24-000237

## Service Provider Letter

Horizon Community Church Expansion

**FIRE CODE / LAND USE / BUILDING REVIEW  
APPLICATION**

FIGURE	
NATURAL RESOURCES	
SITE PLAN OVERVIEW	
6	
DRWN: GPM	CHKD: SKD
AKS JOB: 9349	
HORIZON COMMUNITY CHURCH TIER 2 ALTERNATIVES ANALYSIS REPORT	
AKS ENGINEERING & FORESTRY, LLC	
12965 SW HERMAN RD, STE 100	
TUALATIN, OR 97062	
503.563.6151 WWW.AKS-ENG.COM

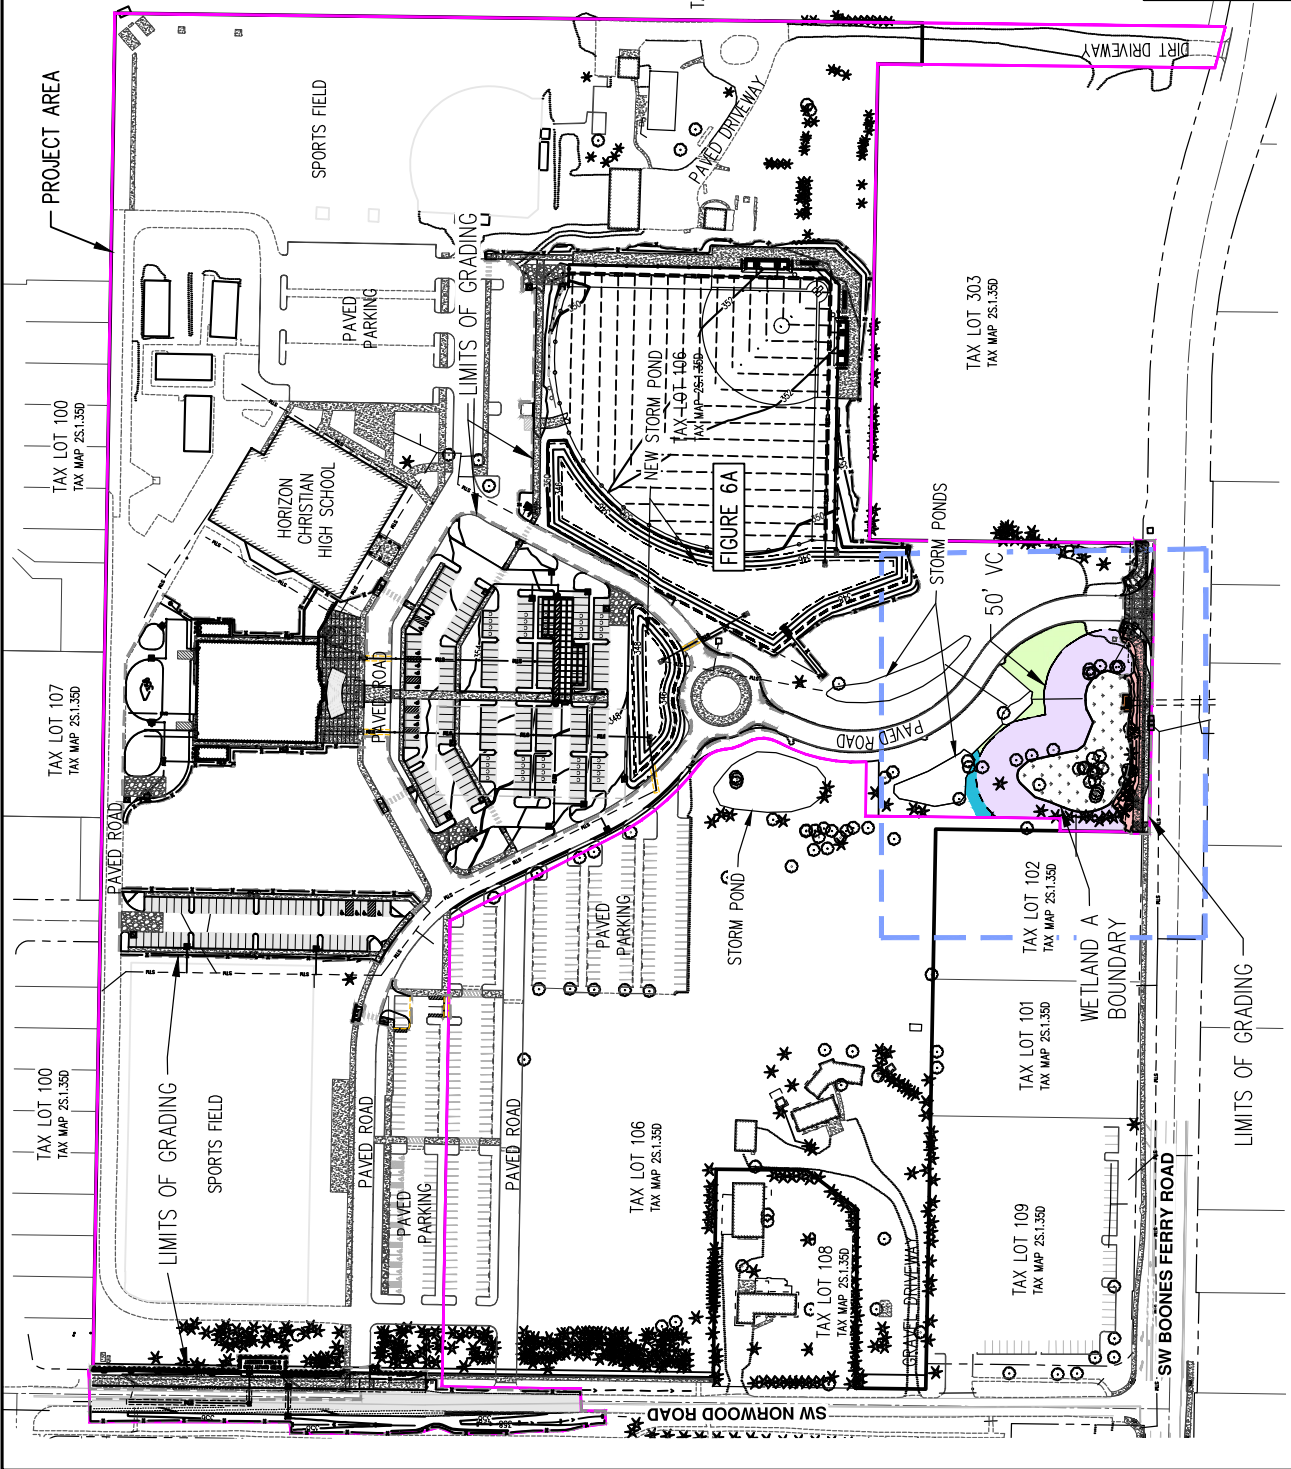
Type and location of Encroachment:	Square Footage:
<u>Road Improvements (Permanent Encroachment; Mitigation Required)</u>	<u>4,907</u>
_____	_____
_____	_____

Type/Location	Sq. Ft./Ratio/Cost
<u>On-site VC Replacement and Public Benefit Mitigation</u>	<u>5,907/1.2:1</u>
_____	_____
_____	_____

# Hydrant Flow Test Exhibit

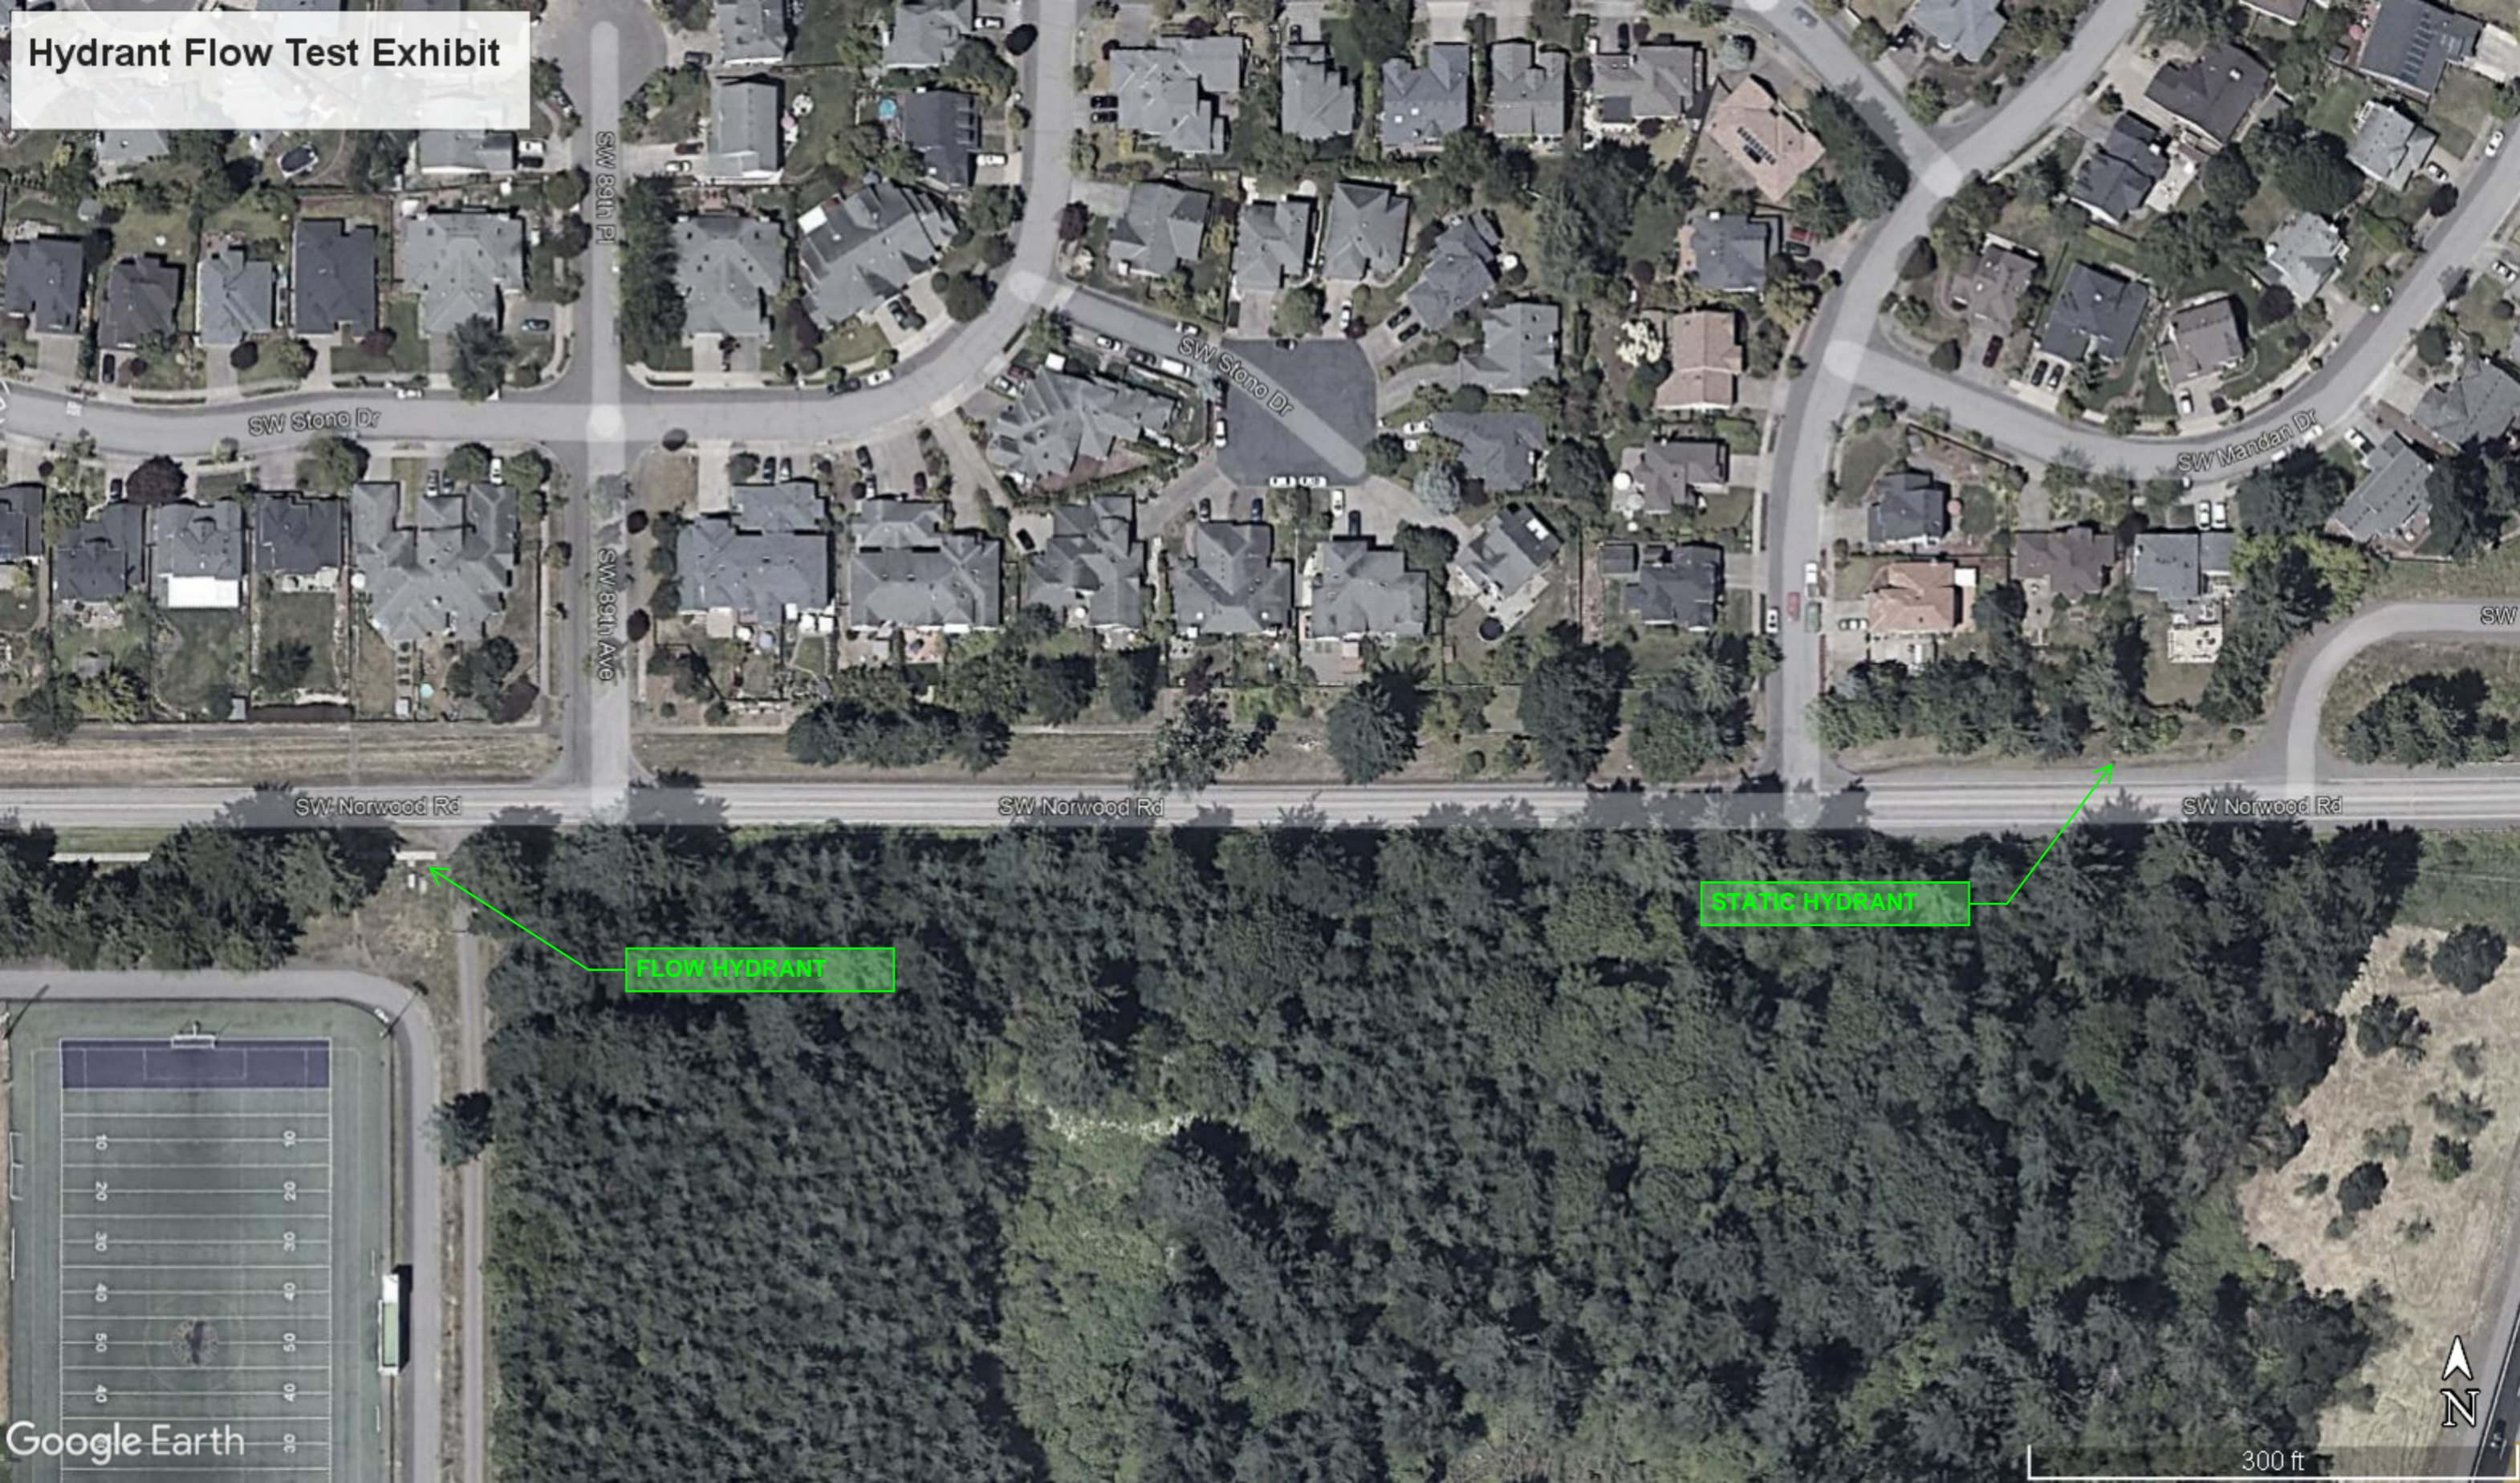
Thanks for the follow up. You are correct on the required fire flow calculation of 1,000gpm. Once I have that memorialized on the site plan as well as the knox box location, and new hydrant flow test I can issue the TVF&R approval.

We also discussed the need to locate the knox box on the site plan and the need for an updated fire flow test from the two hydrants on either side of the proposed building. It sounds like everything else is in order.
